ADDENDUM #2

Project Name:
IMCC Boiler #1 Replacement
DAS#9054.01
RFB 905401-01
Addendum #2
Dated: April 8, 2021

2 FIRST FLOOR PLAN

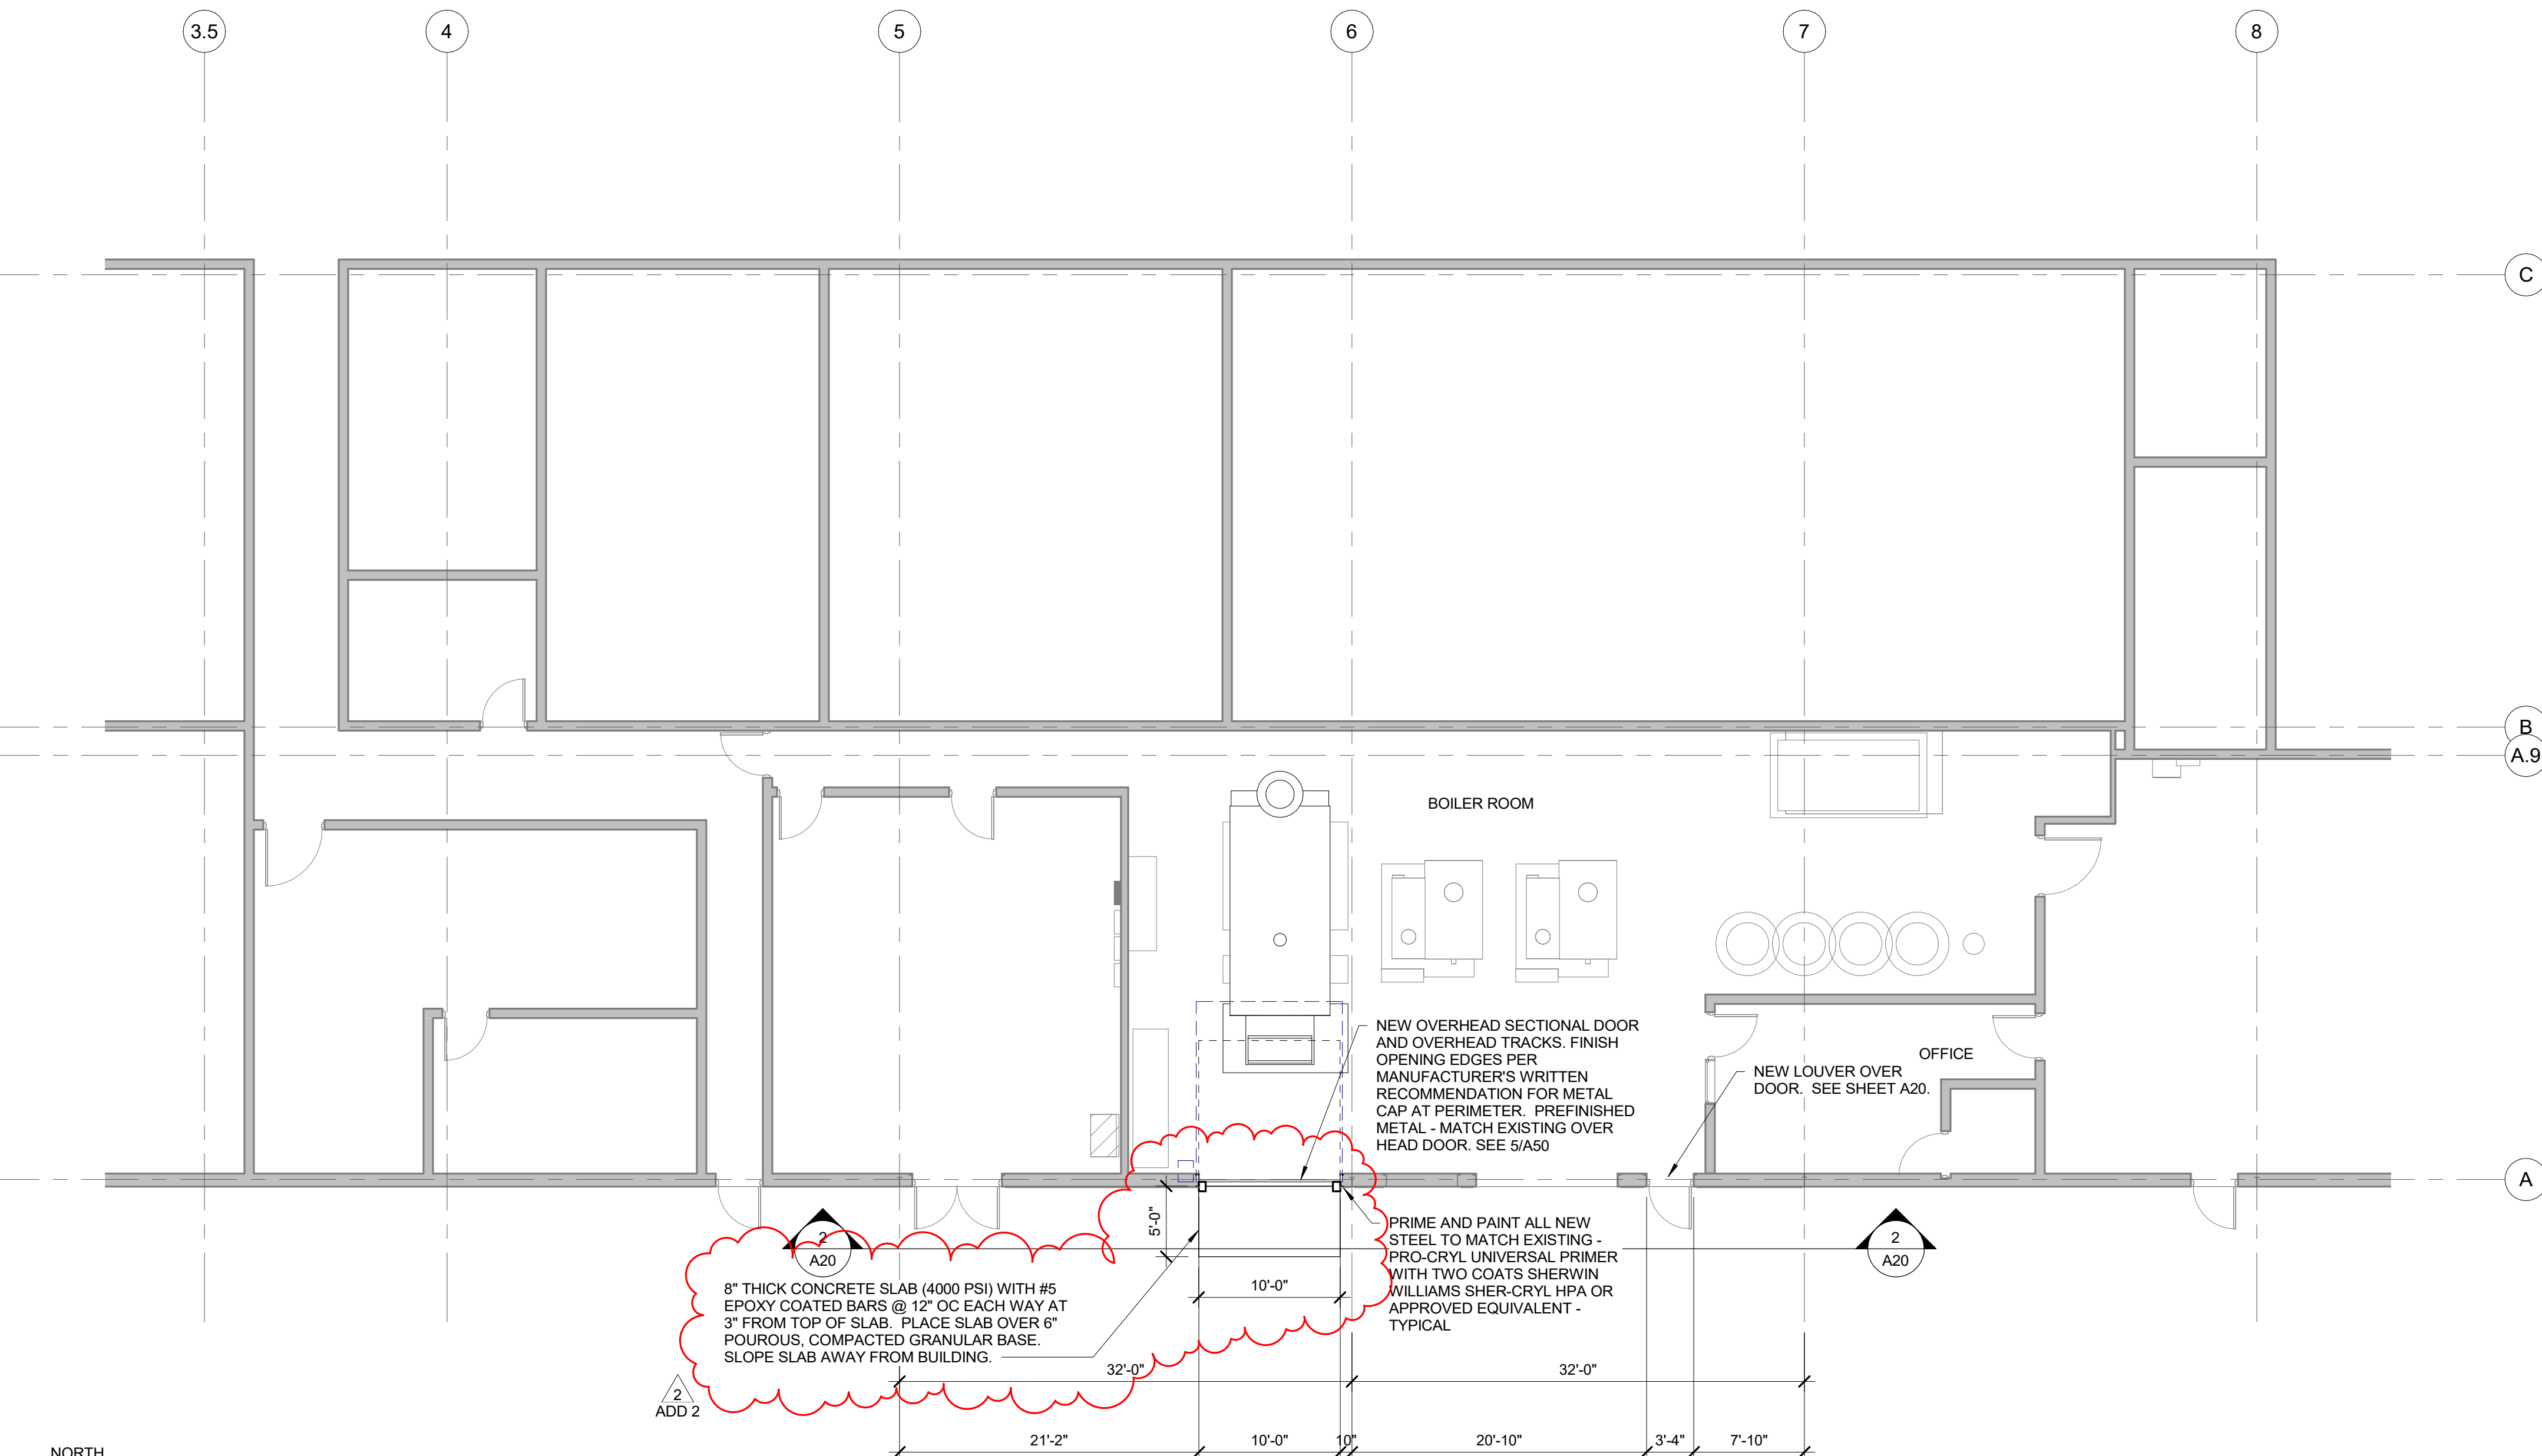
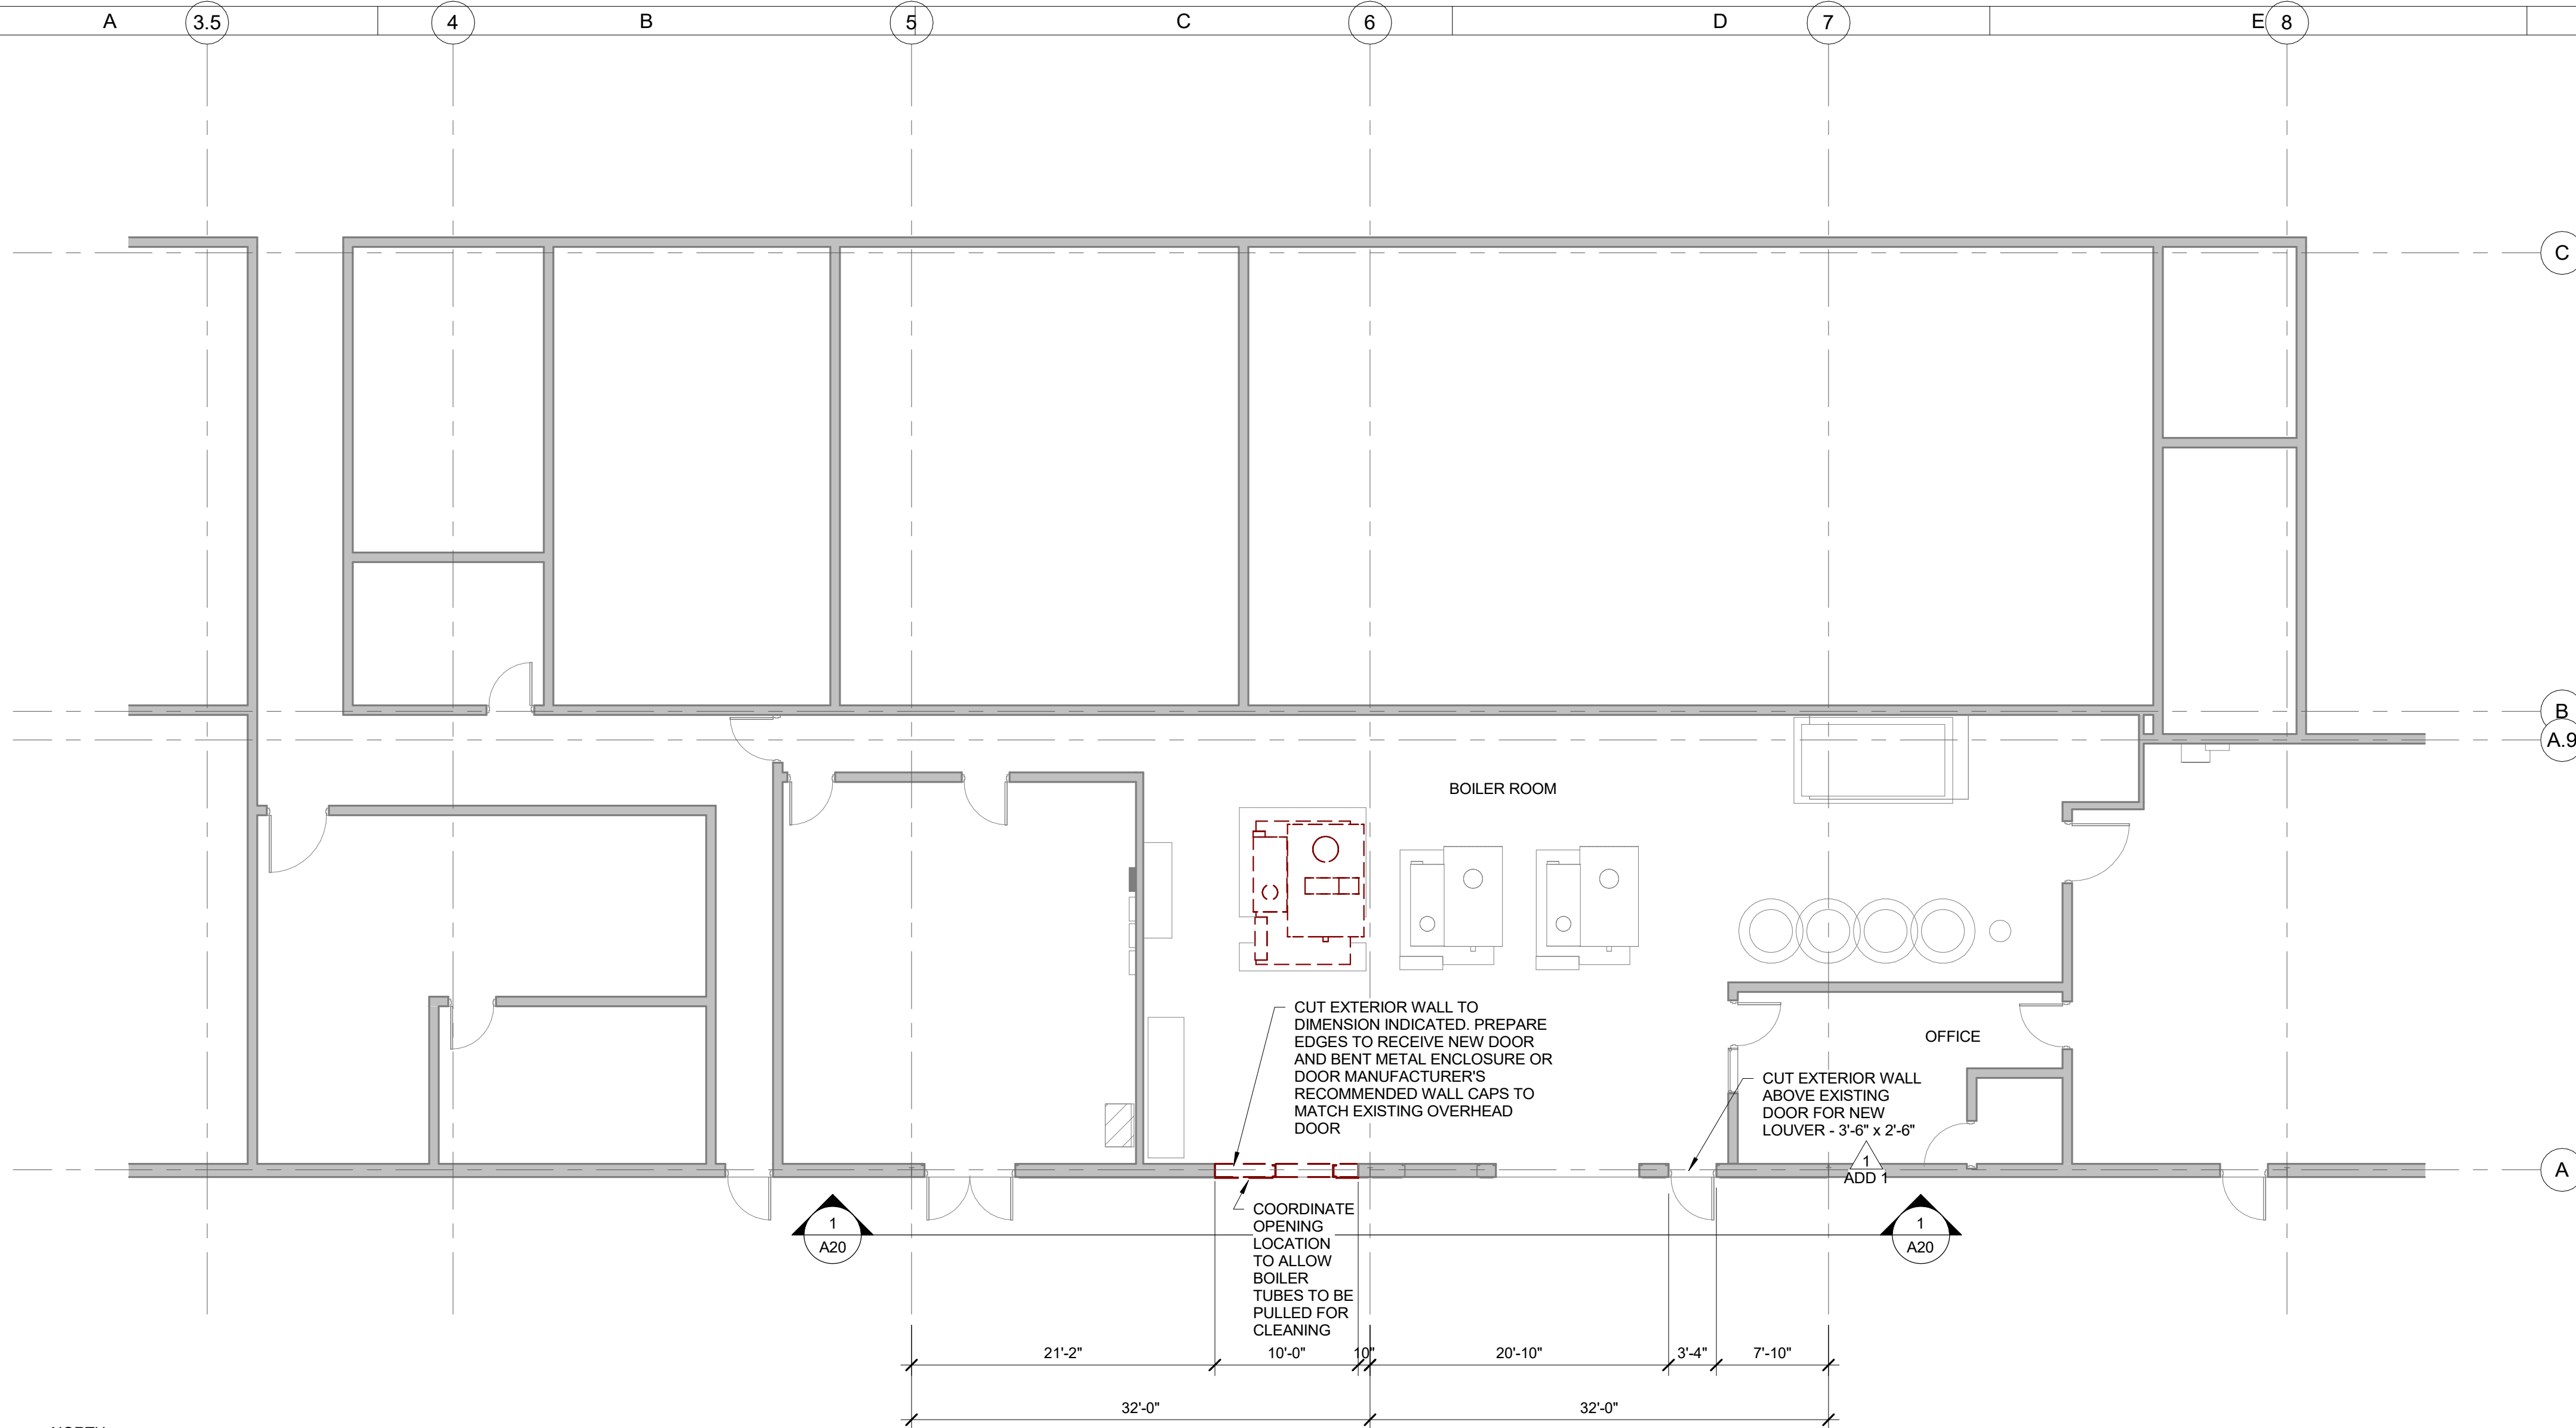
- A. Sheet A10 - Added 10'-0" by 5'-0" concrete approach pad to the exterior of the new overhead door
- B. Sheet M51 – Updated Boiler Schedule
